ACCESS & ADAPTABILITY ASSESSMENT REPORT

RESIDENTIAL FLAT BUILDINGS

12 Carson Lane ST MARYS

S4.55 APPLICATION

14. TYPICAL ADAPTABLE UNIT LAYOUT (TYPE 1)

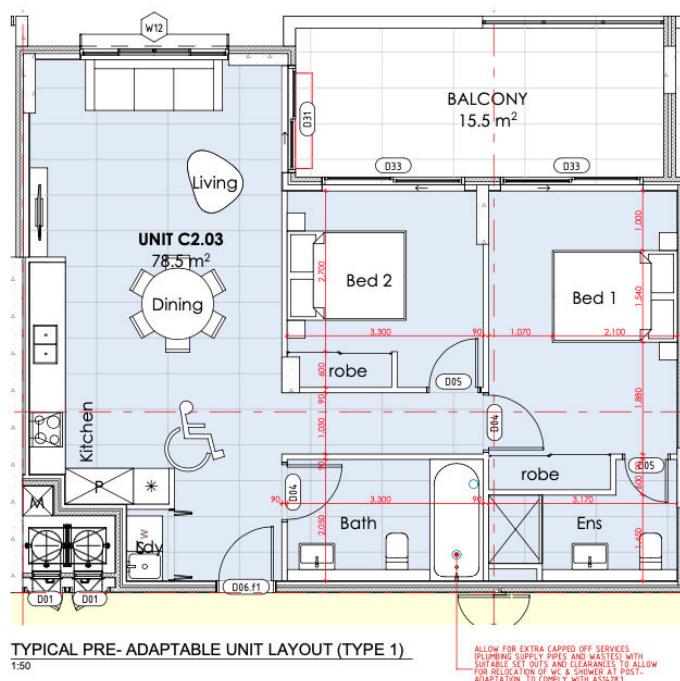
NOTE: The 3800mm wide accessible car parking spaces N°135 and N°156 on Basement 1 and Basement 2 respectively will require a Performance Solution (PS) + Performance Based Design Brief (PBDB) at Construction Certificate stage for the non-compliance of AS2890.6:2009. All other designated accessible parking bays will comply with AS2890.6:2009.
